## ADDENDUM #1

**Date:** 09-05-2024

**Subject:** 2024 Safety Enhancement Program Pre-Bid Meeting

SHEET:  
**C0.02**

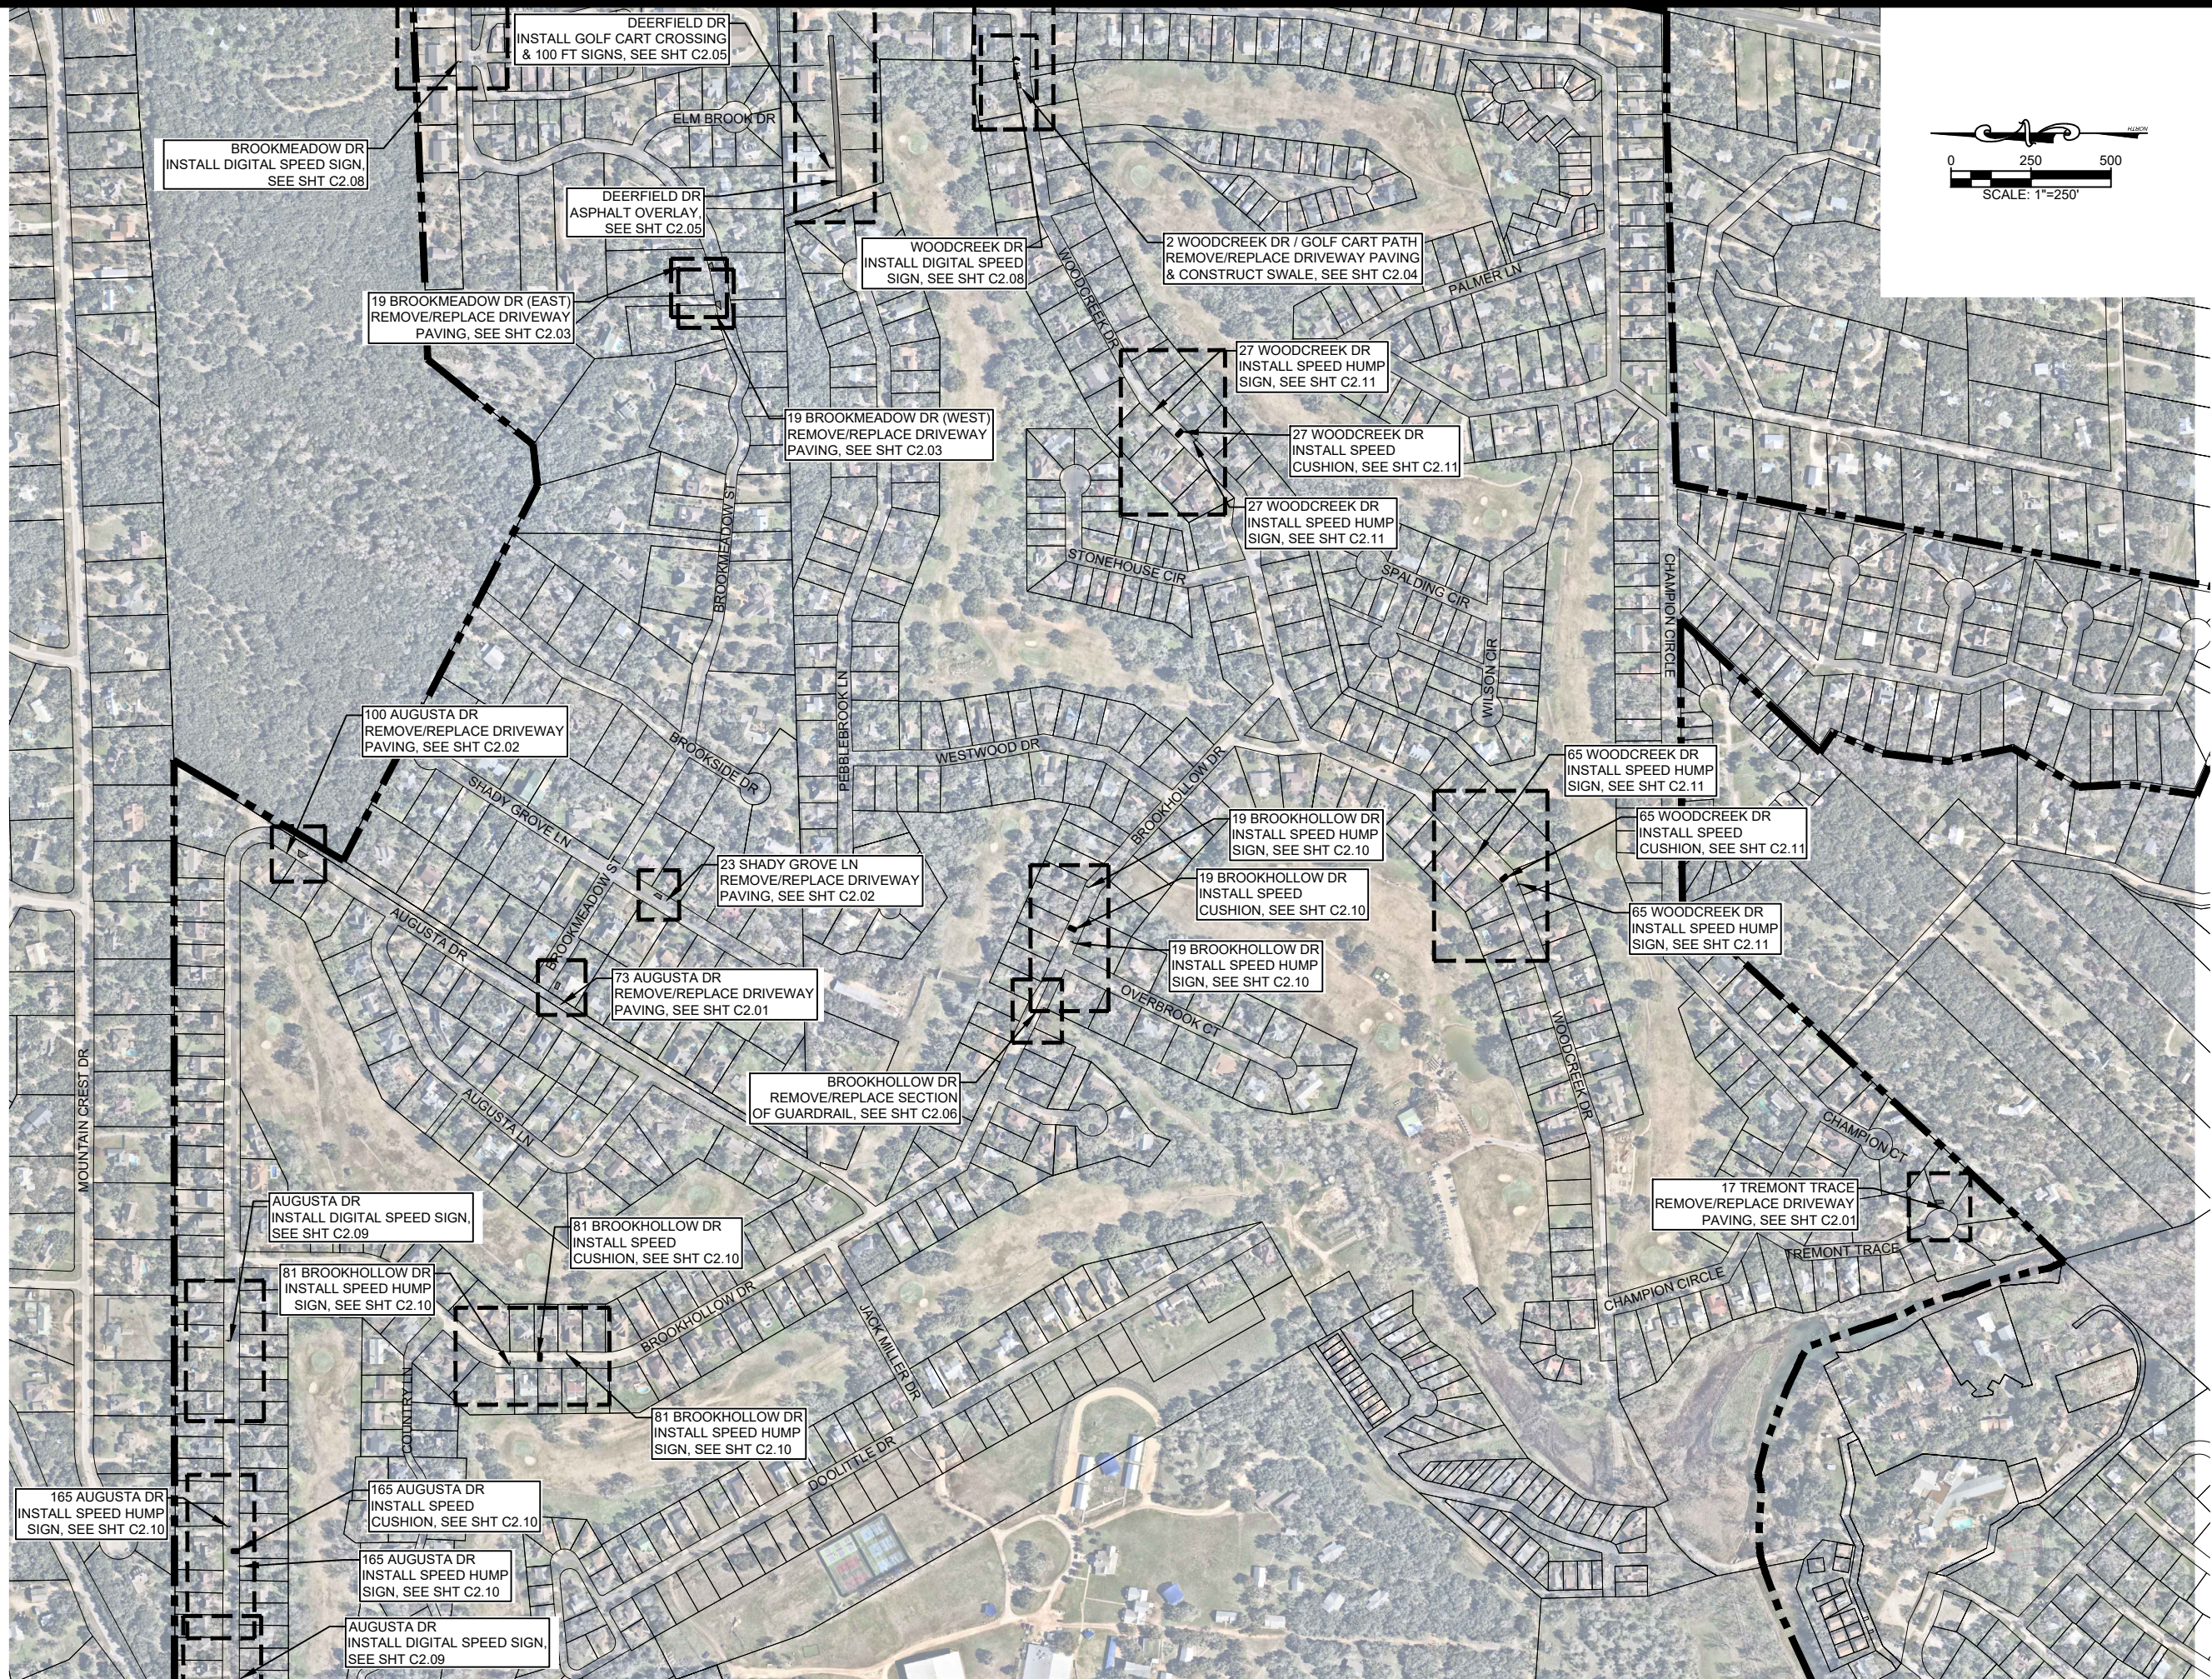
- C0.02 – Revised special specification notes for “Install Provided Digital Speed Signs”
- C2.00 – Revised digital speed sign locations
- C2.09 – Revised digital speed sign locations
